**To** John Rosebrock - Rupp-Rosebrock, Inc.  
**Fax No.** (419) 533-8704  
**From** Adam C. Hoff, P.E. - City Engineer *ACH*  
**Date** 6/26/99  
**Subject** Lutheran Home - Alpine Village Plan Review  
**Pages** 9, including this one

I have reviewed the plans submitted by Mr. Fred Berning, P.E. For the referenced project and developed the following comments:

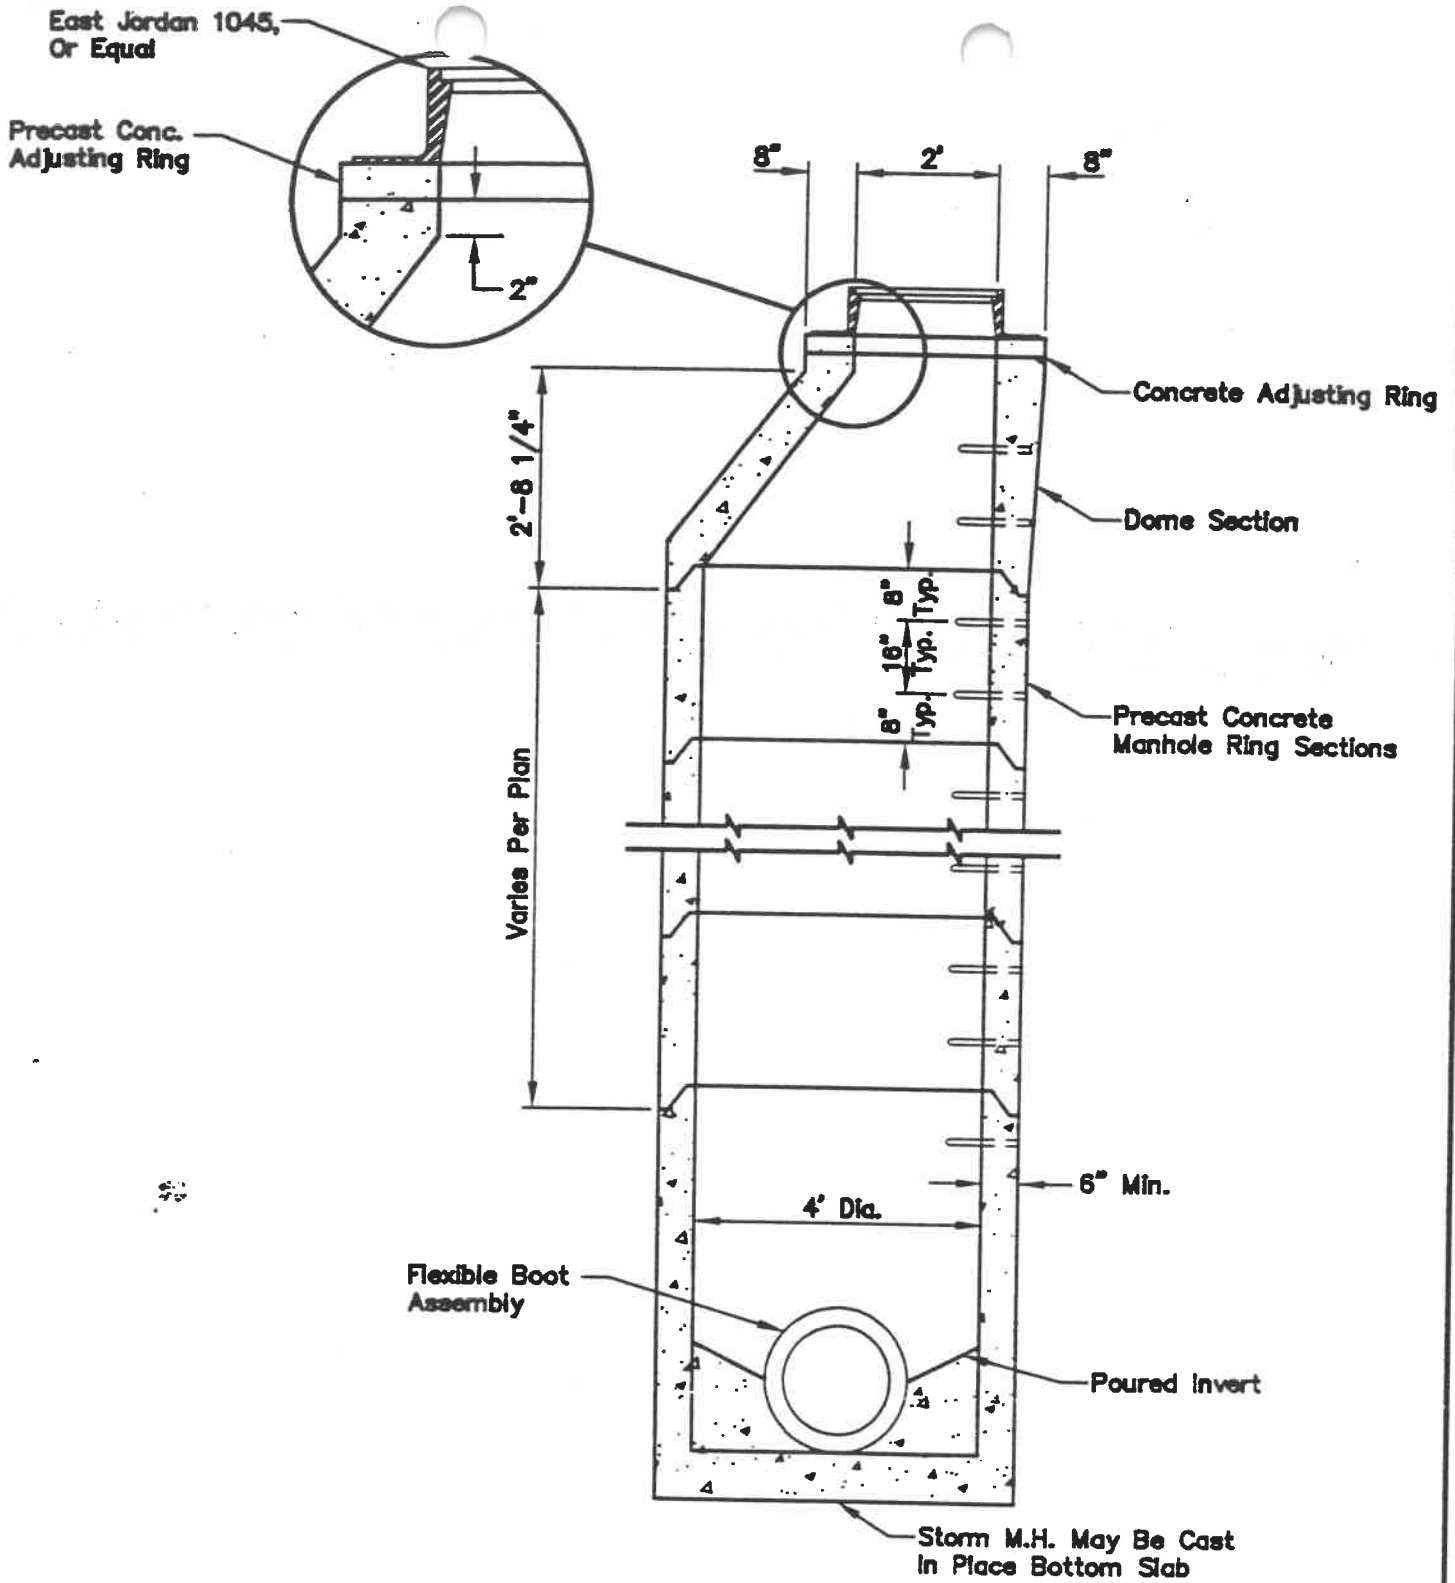
1. Following are two (2) standard details for the City. Please note that our fire hydrants are to be placed perpendicular to the main. Also, note that a minimum of a 2" corbel shall be provided at the top of the cone sections for the manholes.
